INFORMATION LETTER 010

The Airplane Factory (Pty) Ltd issues this Information letter for the safety of Sling aircraft users.

TITLE: Rotax 912ULS airbox seal

Figure 1: Filter edge seal and airbox clips

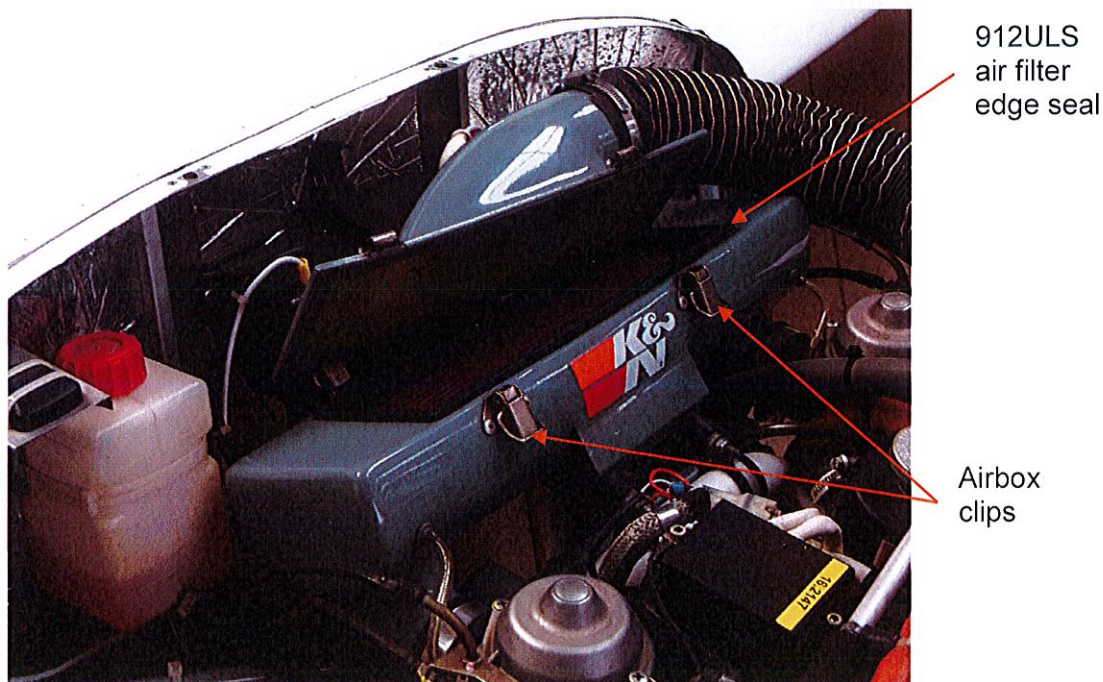
REASON: During initial fitment of the 912ULS air filter, the edge seal (see Figure 1) of the air filter creates a tight seal to prevent ingress of water and other foreign particles into the airbox through its lid. However, the airbox lid may develop some play due to flattening of the air filter edge seal with time.
